Subject: Re-application for Device Evaluation

SUBJECT: REQUEST FOR ADDITIONAL INFORMATION REGARDING CSECO EXEMPT
DISTRIBUTION LICENSE APPLICATION AND SEALED SOURCE AND DEVICE
REGISTRATION CERTIFICATE APPLICATION

Docket No. 030-38916
Mail Control No. 590618

K910 B - EXTERNAL

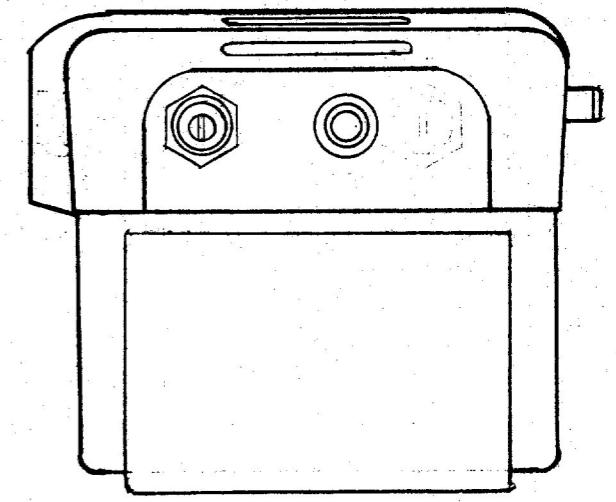
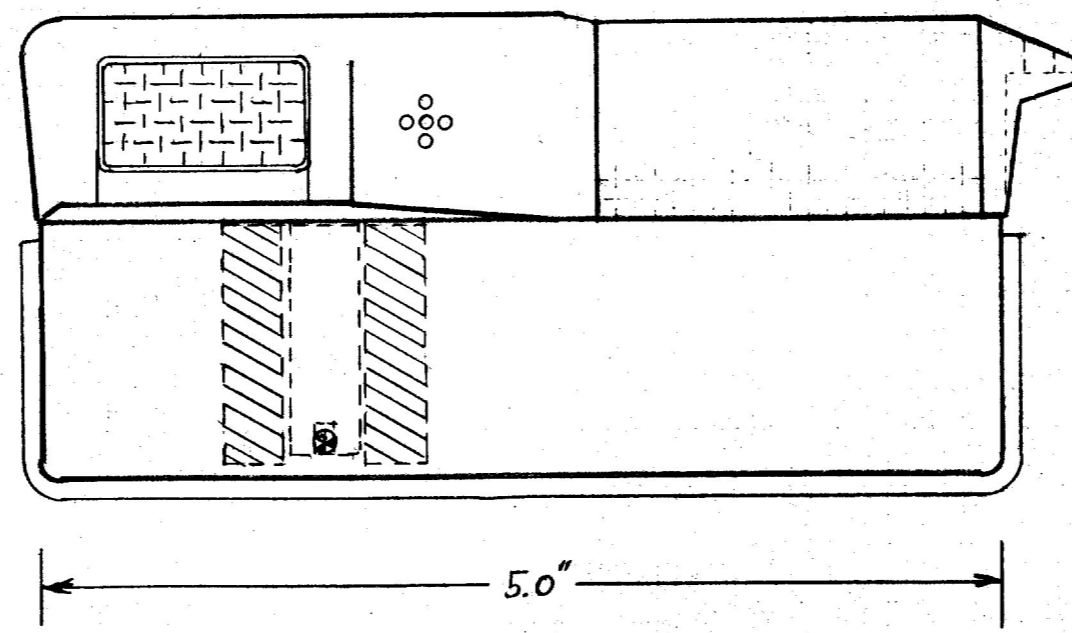
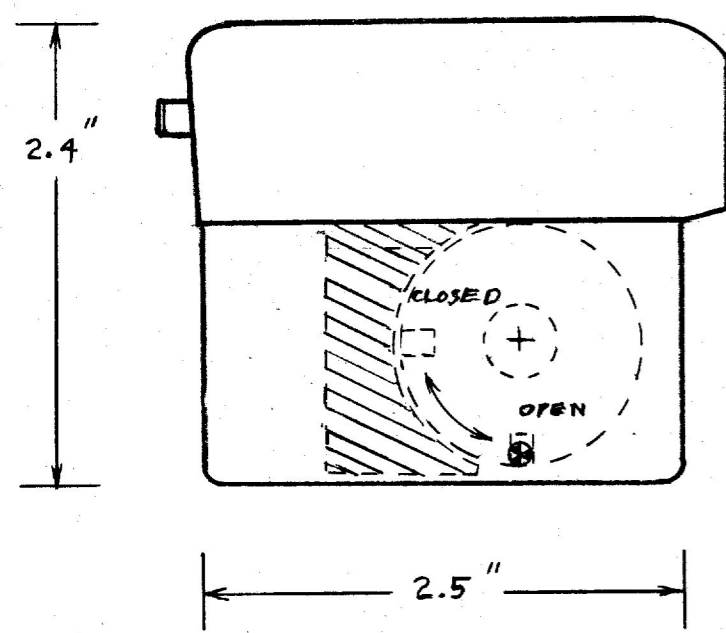
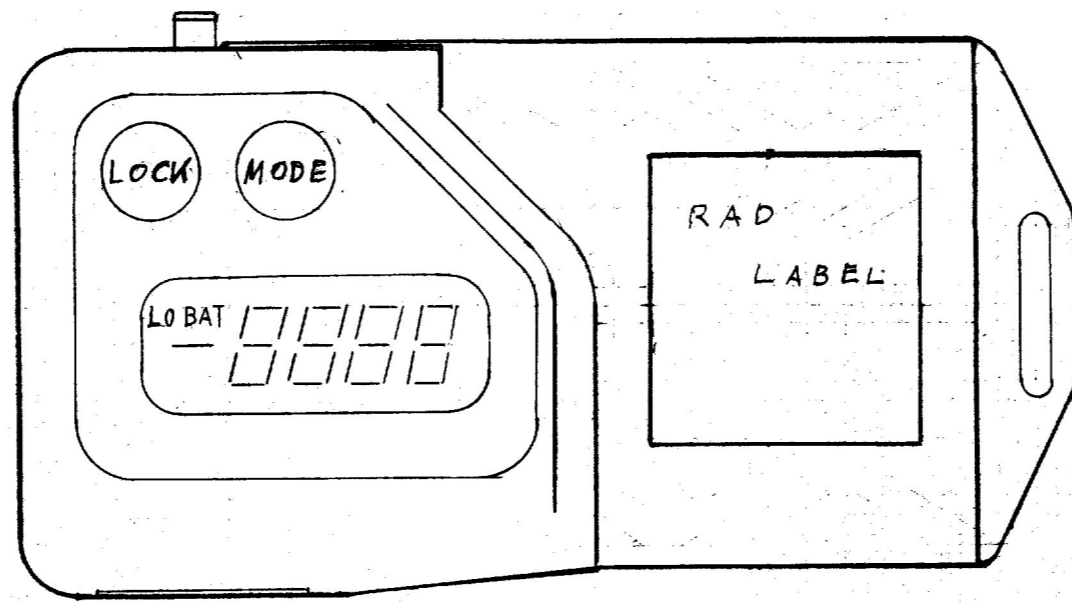
2. The following items concern the review of your application for a sealed source and device registration certificate:
 - a. Please provide a non-proprietary version of the drawing “K910B – External”, including the overall dimensions of the K9 Series devices so that it may be included as an attachment to CSECO’s registration certificate.
